TECHNICAL SERVICE BULLETIN

Number: TSBUMTS-005(PC Card Adaptor RF Int.)

Description Summary: PC Card Adaptor RF Interference

Documented: January 10th 2007

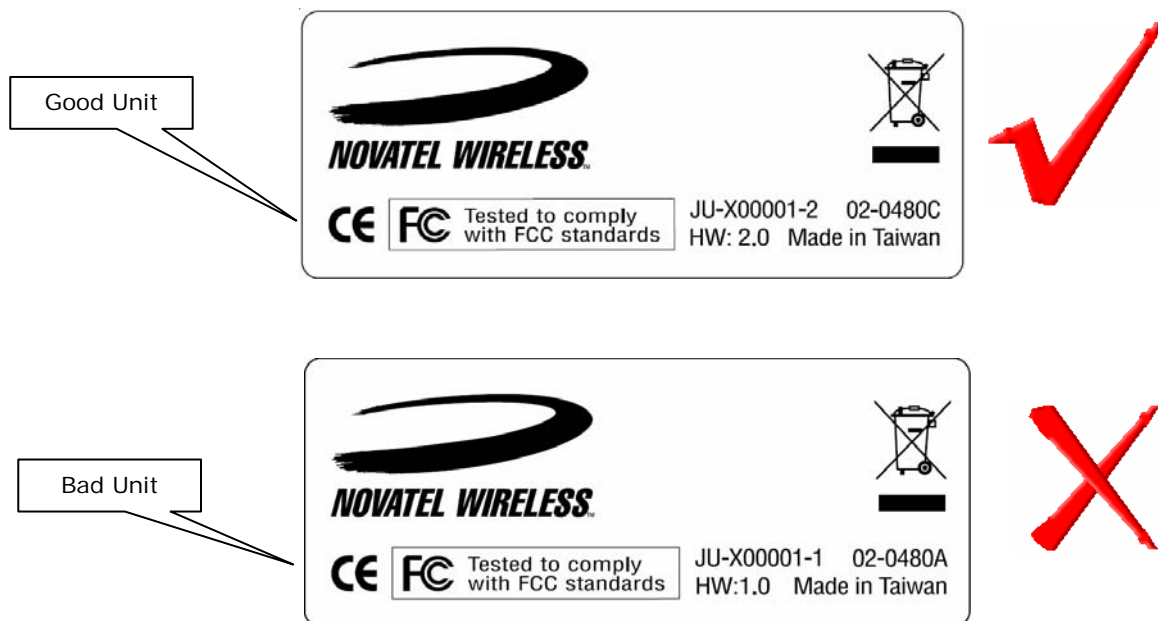
When an ExpressCard is used with the PC Card Universal Adaptor XCA-2 displaying Part Number JU-X00001-1 on the label, the PC may completely lock up (freeze), requiring a reboot. This has been occasionally observed on a few laptop models. This is only observed when in GPRS mode.

The reason for this behavior is a hardware problem located in the PC Card Universal Adaptor XCA-2 Part Number JU-X00001-1

The solution is to replace the PC Card Universal Adaptor XCA-2, Part Number JU-X00001-1 with PC Card Universal Adaptor XCA-2 Part Number JU-X00001-2

The Part numbers are visible on the label as shown.
